# SERVICE BULLETIN

M-1195 August 18, 2006

# 2007 FLSTF FORK SLIDER COVER PRODUCT PROGRAM 0901

The purpose of this bulletin is to alert dealers to the possibility that the front fork slider covers may damage the front fender of 2007 Fatboy motorcycles if the front forks are fully compressed.

Figure 1. Front Fender-Area of Potential Damage

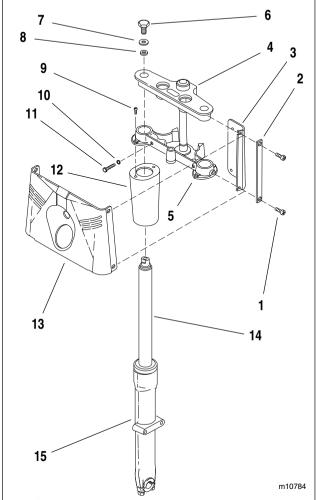
- See service manual for specific removal and reassembly procedures.
- When installing parts, tighten all fasteners to the correct torque specified in the service manual.
- See Figure 1. Inspect top right corner of front fender for damage and repair using Finesse kit, or order replacement fender if required.

Figure 3. Sleeve

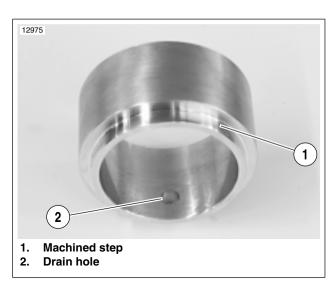
Replace both fork slider covers (see Figure 5.) and install a sleeve (see Figure 3.) into the end of each fork slider above the seal area. See procedure which follows.

- 14. Unscrew and remove right slider tube cap (6), washer (7) and oil seal (8). Discard oil seal.
- Loosen pinch bolt (11). With a gentle twisting motion, pull right fork tube and slider assembly (14, 15) down and remove from vehicle.
- 16. Remove two screws (9) and right slider cover (12).
- See Figure 3. Retrieve one **new** sleeve from service parts kit. With machined step (1) pointing down, slide cap down fork tube until it contacts slider assembly.
- 18. Position sleeve so that drain hole (2) will face rear of vehicle when fork is installed. Using the FORK BUSH-ING AND SEAL INSTALLER (Part No. HD-34634), drive sleeve into top end of fork slider until sleeve bottoms out against top lip of slider. See Figure 4.

Figure 5. New Slider Cover (Right Side Shown)

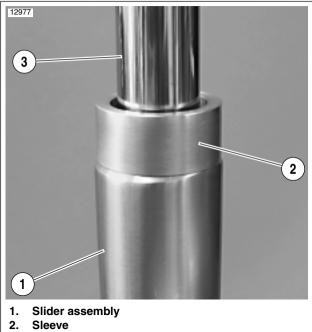
See Figure 5. **New** fork slider covers are not identical to each other as were the original covers. New covers are a matched pair. Each cover is notched (1) on one side at bottom. To identify new left and right slider covers, hold covers with seams (2) facing rear of vehicle. Notches must face inward toward fender.

19. See Figure 5. Retrieve **new** right slider cover from service parts kit. Position slider cover on lower fork bracket with seam (2) facing rear of vehicle and notch (1) facing toward fender. Secure with two screws.
